North West Rapid Transit Expert Panel
c/- Mujadid Musa, Application Lead
Environmental Protection Authority

**RESPONSE TO INVITATION TO COMMENT UNDER SECTION 70 FAST TRACK APPROVALS
ACT – NORTH WEST RAPID TRANSIT**

ATTACHMENT 1 – REASONS FOR REQUESTED CHANGES TO CONDITIONS

i. Designations subject to Designation Condition 27A:

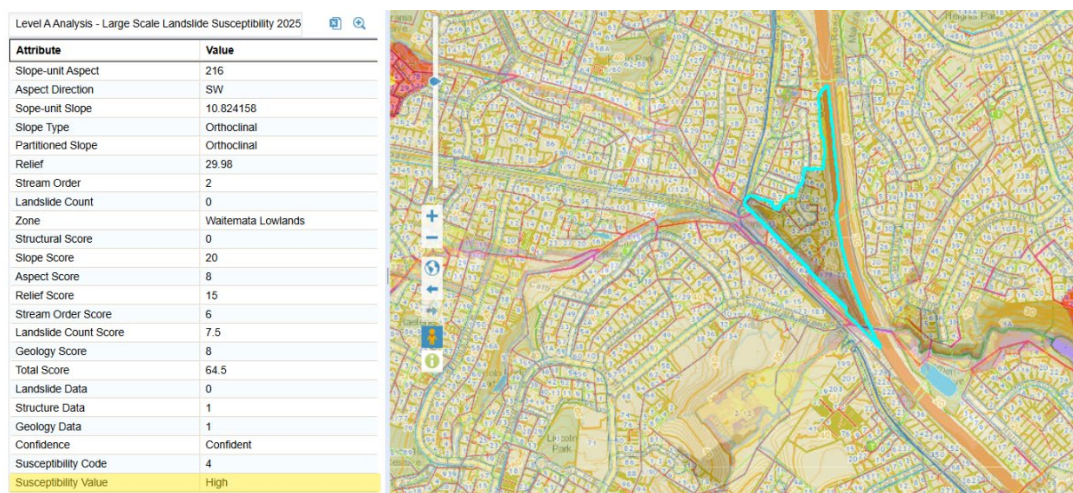
AC planners note the Panel has some concern with respect to AC's recommendation that the Geotechnical Management Plan condition 27A apply to all designations [p.244]. As a result, the Panel focused on those designation areas (Waterview interchange and Arch Hill Reserve) identified in Mr Hall's technical memo and conclude condition 27A should be limited to NoR 9 and 10.

- Request designation condition 27A apply to all designations – AC engineer is willing to consider re-drafting of condition to enable a “geotechnical risk review” alternative pathway to enable the Requiring Authority at detailed design stage to confirm areas where full geotechnical management plan should not be required for a stage of works.
- Request designation condition 27A is amended to require the information be provided as part of the outline plan process. This was missed from AC's original drafting however

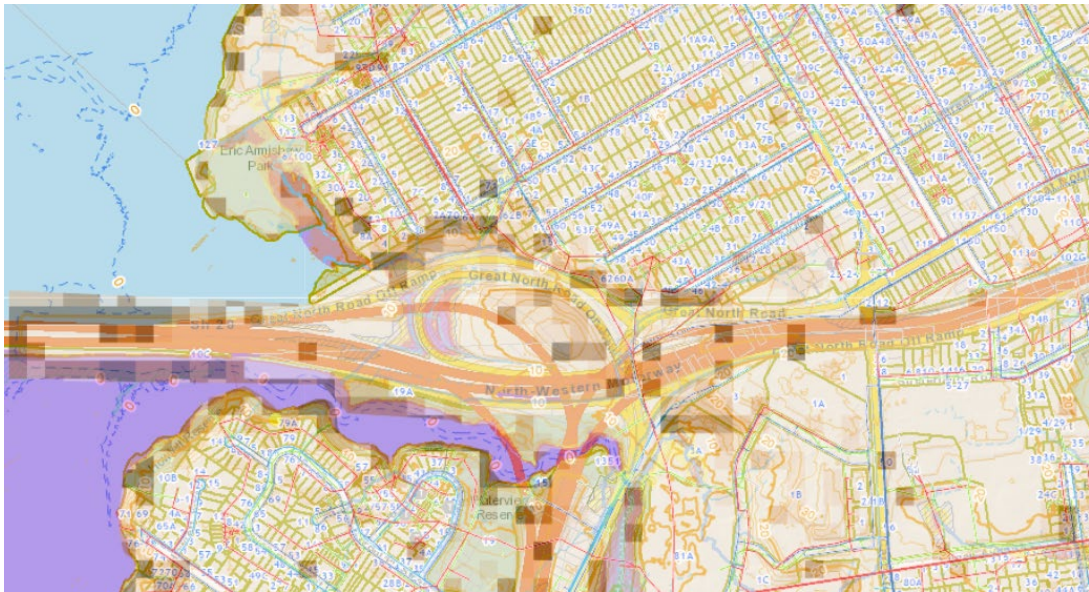
There are a large number of Shallow Landslide Susceptibility points across the alignment. As per my memo, these most likely reflect cuts and embankments along the existing motorway, or with respect to stream gullies, however it's again not for me to assess each of these to decide what effect the works may or may not have on adjacent land, buildings or infrastructure due to these potential hazards.

I believe limiting the GMP to only the Arch Hill Scenic Reserve is not appropriate, as the area of concern extends beyond only the reserve.

At the Waterview interchange, there is evidence of geotechnical hazards and steeper slopes, as per Council's GIS below. However, whether this is of any concern would only become apparent with the detailed design. This could be a location where a Geotechnical Risk Review at design stage would resolve the issue [as to whether a full Geotechnical Management Plan is required], and we can easily move forward.
